ADDENDUM No. _2

Date October 3, 2016

Project Name Taylor Lane 0.1 MGD Wastewater Treatment Project

C.I.P. No. 3353.095 IFB No.: IFB6100 CLMC600

DWG. NO.
C-11
 SHEET 27 OF 79

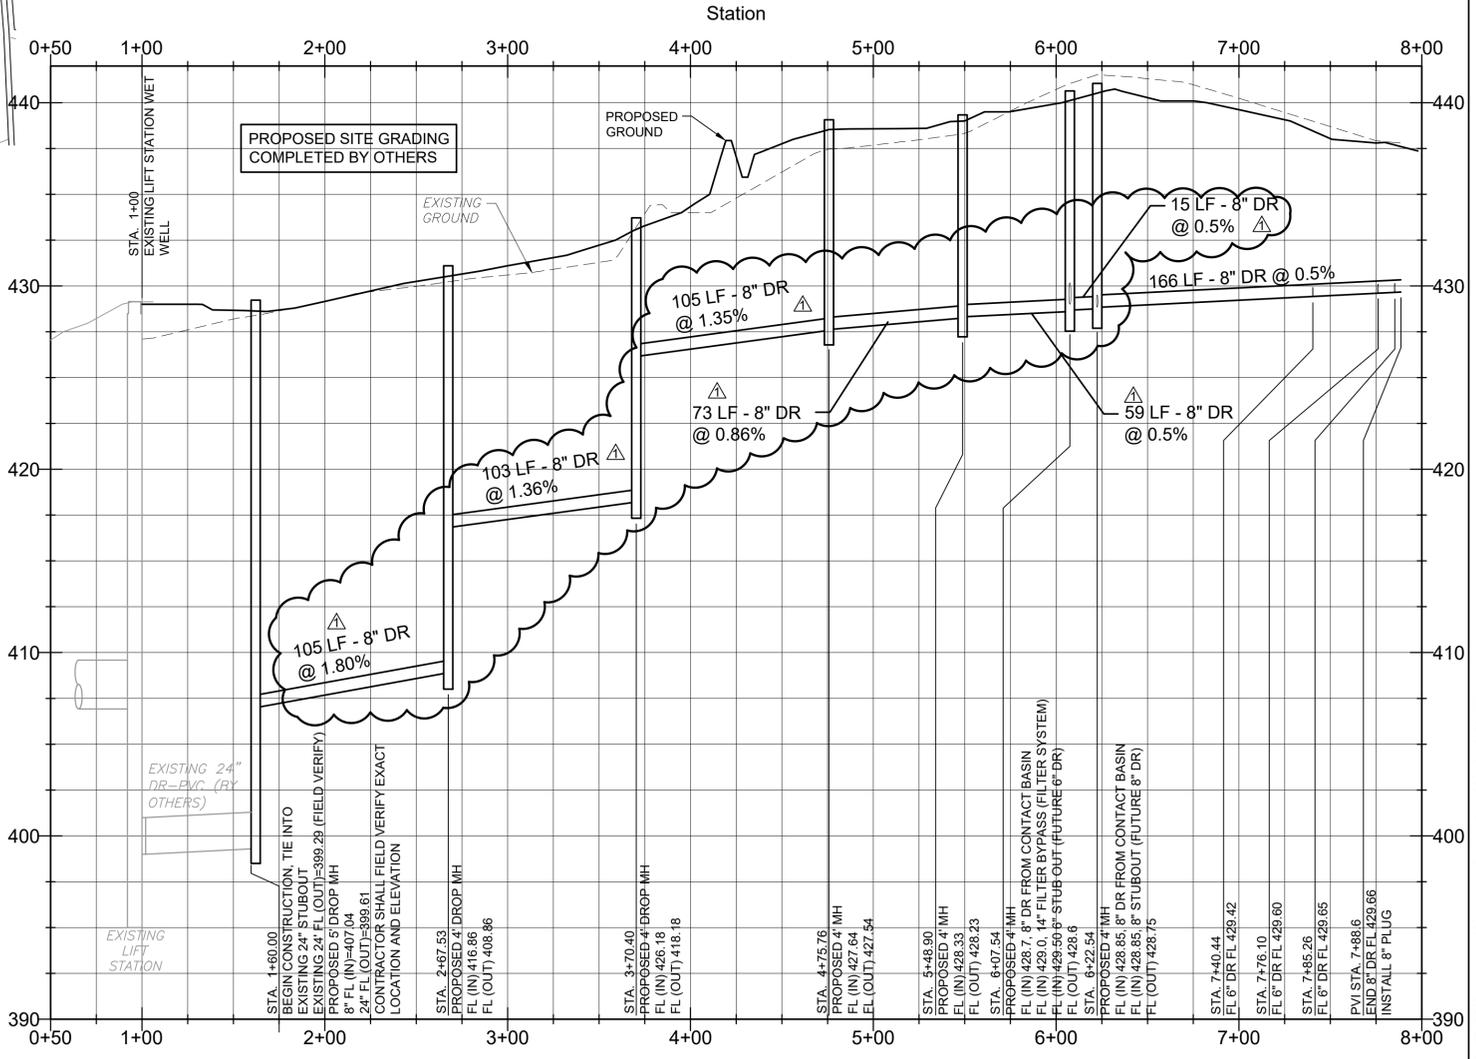
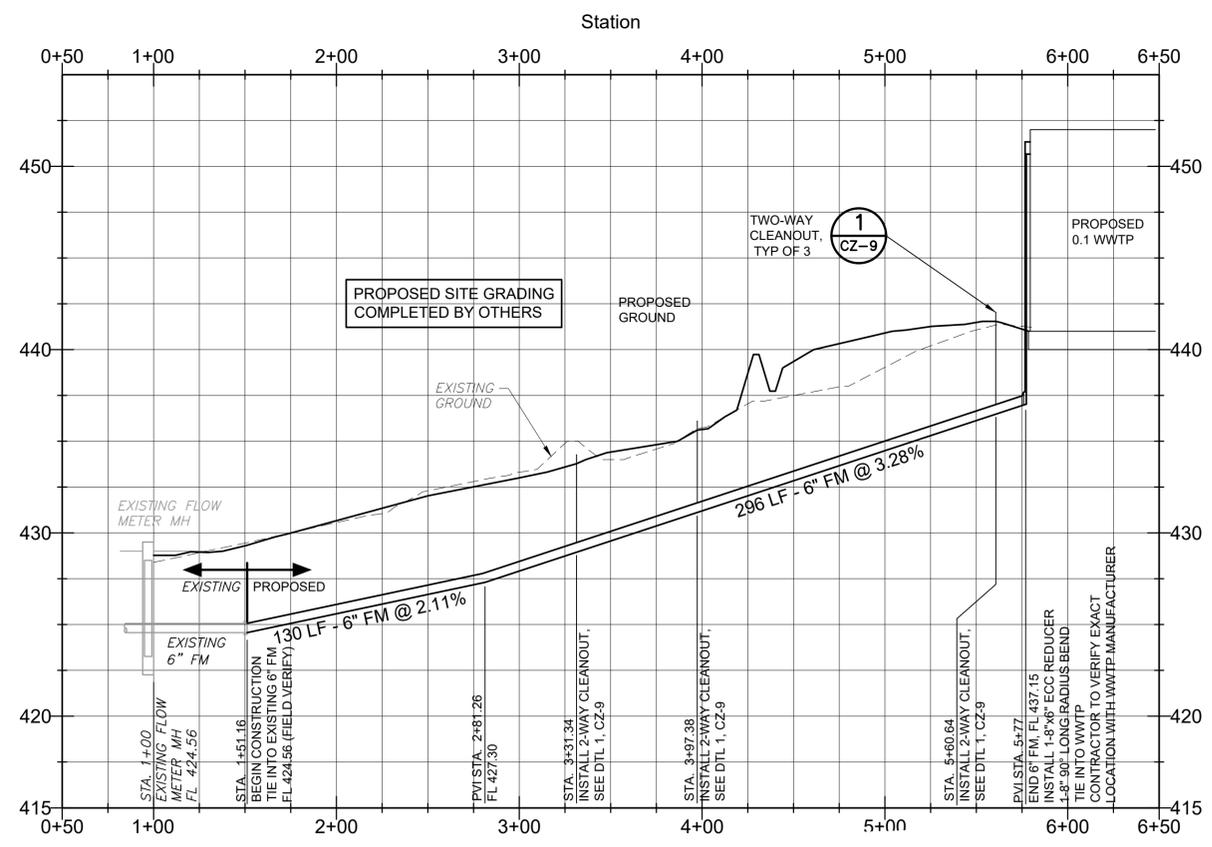
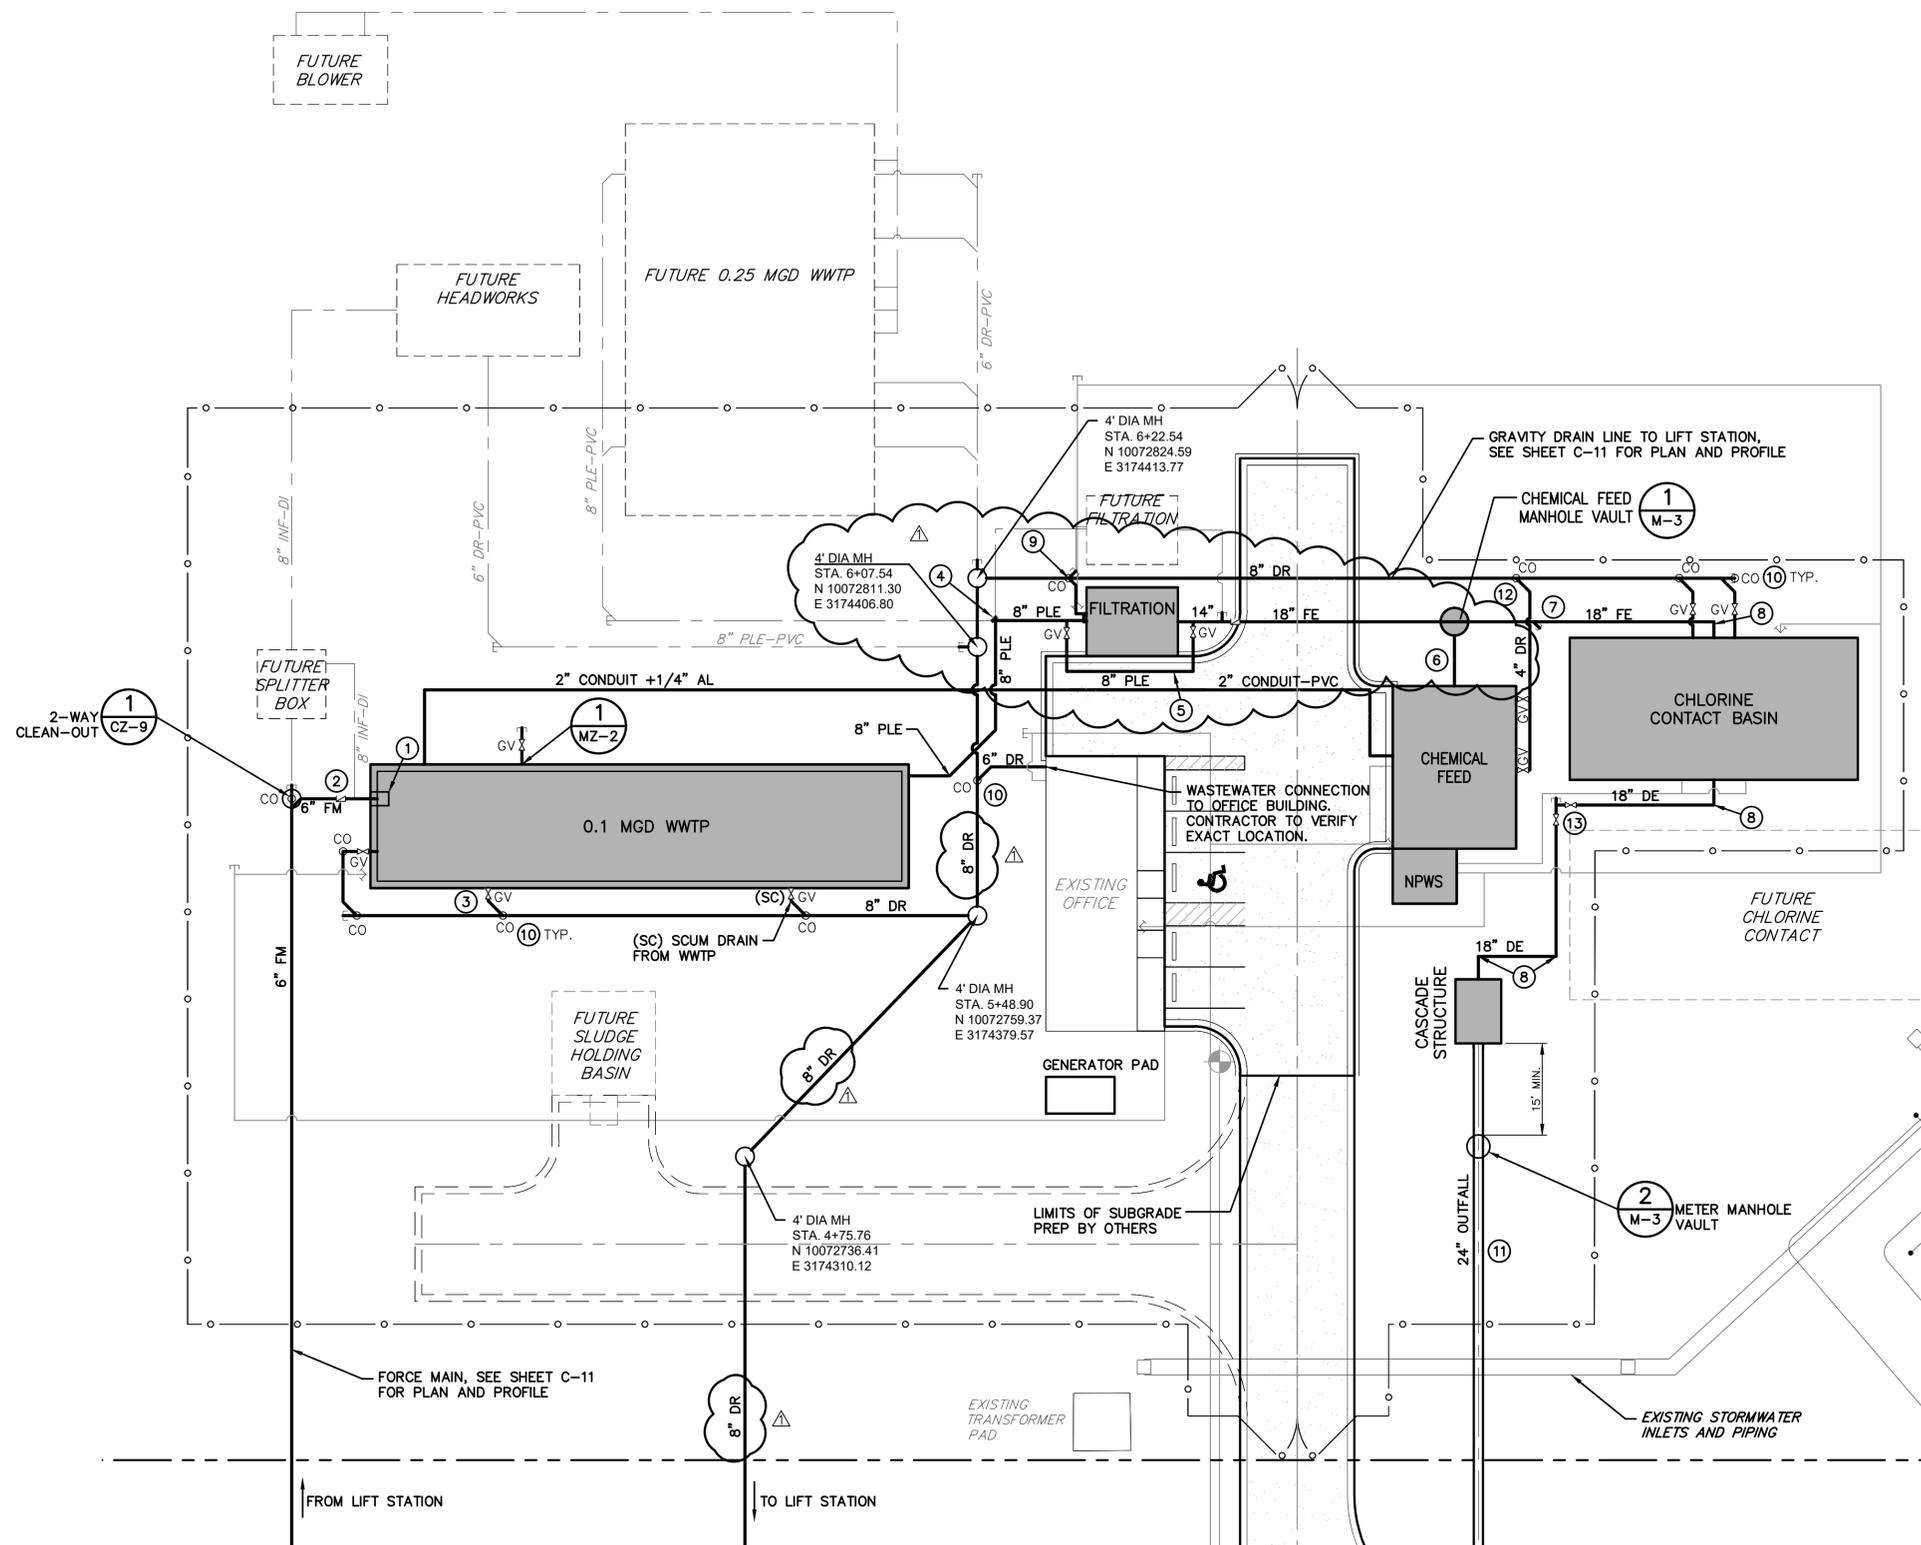
REV	DATE	BY	DESCRIPTION	APPROVED
ADD2	9-20-2016	RJR	YARD PIPING	SST
